MILITARY SPECIFICATION

INDICATOR, BEARING-DISTANCE-HEADING ID-1103/ARN

This amendment forms a part of Military Specification MIL-I-38357A (USAF) dated 21 December 1971.

FIGURE 1. Dial and Pointers

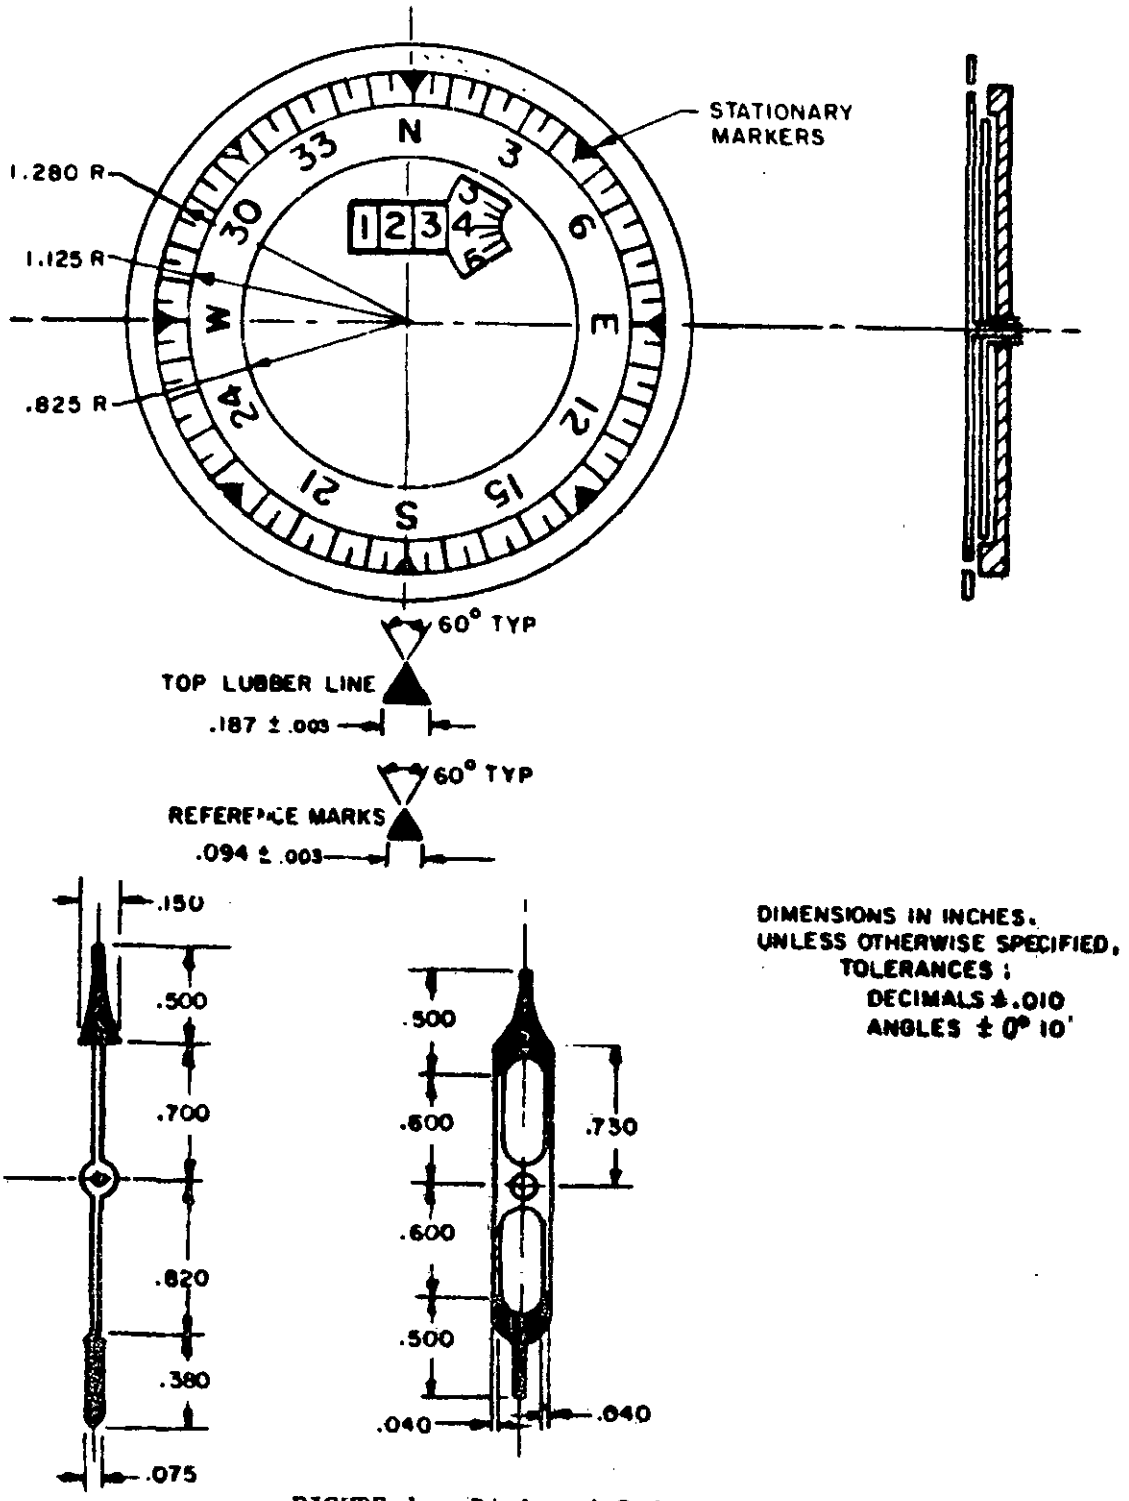
3.4.5, first and second sentences: Delete and substitute: "Unless otherwise approved by the procuring activity (see 6.2.2), the dial shall be in accordance with figure 1 and all visible portions of the dial shall be lusterless black, color No. 37038 of FED-STD-595".

Figure 1: Delete and substitute the attached figure 1. Figure 1 forms page 2 of this amendment.
